AUSTIN QUARRY PROJECT

ADDENDUM TO FINAL ENVIRONMENTAL IMPACT REPORT

SOLAR FACILITY AND PHASE ADJUSTMENT

April 11, 2023

Figure 1. Aggregate Mine Phases with Requested Modifications
 Austin Quarry ITP Amendment (4571-03)
 November 2022

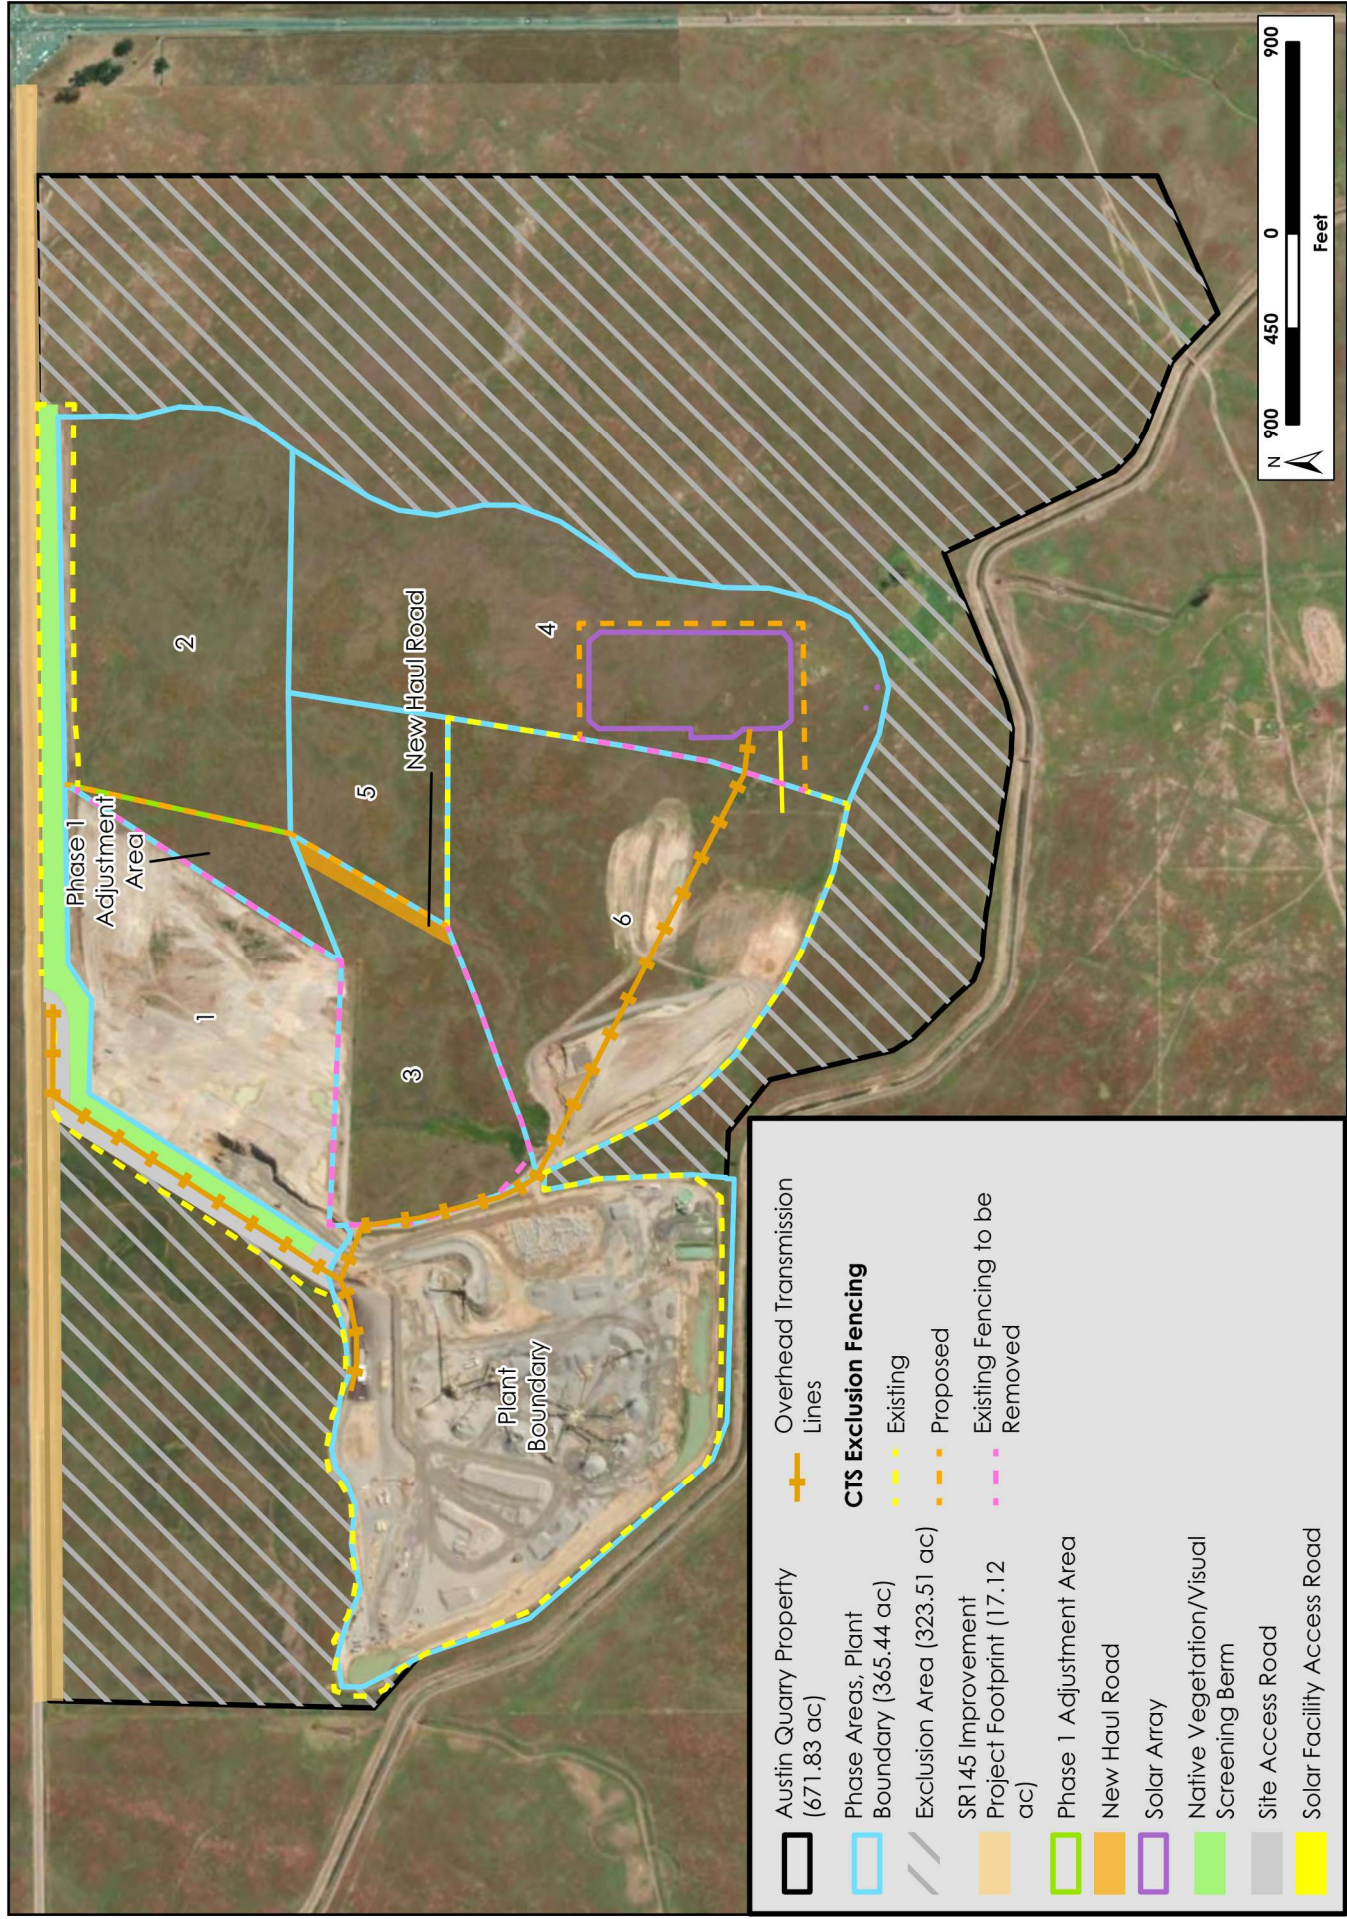
The Solar Facility includes installation of a 7-acre solar facility on up to 10 acres of land in the southern portion of Phase 4 of the planned mining disturbance area. (See Figure 1.) A perimeter fence and road would be installed surrounding the arrays and transformers, and within the overall approximately 10-acre footprint. The energy produced by the Solar Facility would be utilized at the Austin Quarry, which would reduce the amount of electricity used from offsite sources and would contribute to the state of California meeting its Renewable Portfolio Standard of 50% renewable energy by 2030.

The Phase Adjustment will modify the Phase 1 and Phase 2 boundaries of those to phase areas, but with no change in the overall Quarry footprint. To support operational activities, including mining in Phase 1, Vulcan proposes to adjust the Phase 1/2 boundary by moving it eastward to encompass 6 acres currently within the Phase 2 area (Figure 1). The area within Phase 2 that will be reassigned to Phase 1 is termed the “Phase 1 Adjustment Area” in Figure 1. This adjustment is necessary to efficiently mine Phase 1 and prepare for mining Phase 2 at a future time. In addition, as part of the Phase Adjustment, Vulcan will add a new haul road from the updated Phase 1 area to Phase 6. This new haul road is necessary to efficiently mine Phase 1 and to provide efficient access to the Phase 6 overburden stockpile area. The proposed haul road will be on the interior of the eastern border of Phase 3 area (Figure 1). The haul road disturbance is entirely within areas previously anticipated to be disturbed during Austin Quarry development. The expansion of Phase 1 will facilitate haul road access between phases. The timing of anticipated phasing will be adjusted to account for the revised acreage.

the County, with a minimum height of 6 feet) surrounding the Solar Facility, and one access road and double swing gate leading into the solar facility through Phase 6. (See Figure 1.) The solar arrays will be approximately 10 feet above ground. A 6-foot by 12-foot concrete pad will be constructed for the inverters, battery, and transformer. As above-ground wiring is planned, there will be minimal trenching on the Solar Facility site, with an approximately 200-foot trench planned from the DC combiner boxes to the inverter pad.

An overhead electrical distribution line mounted on 35- to 40-foot-tall, wood poles will connect the Solar Facility in Phase 4 to the overhead distribution circuit within the processing plant site, which will connect to a directional power relay with radio signal to battery management control, a recloser, and a PG&E service disconnect switch and PG&E pole meter, located near the entrance of the mine site along SR 145. The location of the Solar Facility and associated infrastructure (e.g., overhead transmission line, PG&E service disconnect switch, and PG&E pole meter) are designed to be primarily within the existing boundaries of Phase 4 of the mine disturbance area analyzed in the 2016 FEIR, with the overhead transmission line crossing Phase 6 and connecting with the entrance road.
